**Subject** ▶ Changes on Blade Case Complete and Screw M6x14

**For Models** ▶ 5903R and 5903 (235mm Circular Saws)

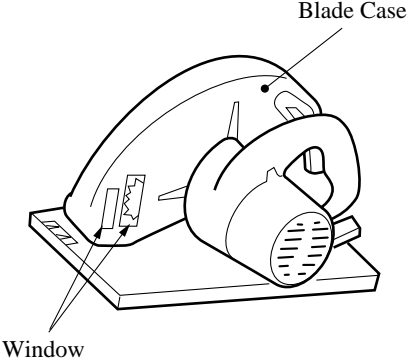
**Description** ▶ As illustrated below, window has been added on Blade Case Complete and Screw has been changed.

▶ Current	▶ New
Blade Case Complete		 <p>Blade Case</p> <p>Window</p>
Screw	 <p>Screw M6X14</p>	 <p>Screw M6x15</p>

Item No.	Current part	Q'ty	I/C	New part	Q'ty	
49	Blade Case Complete 152495-4	1	<=	Blade Case Complete 152550-2	1	
75	Screw M6x14 265701-9	1	<=	Screw M6x15 265726-3	1
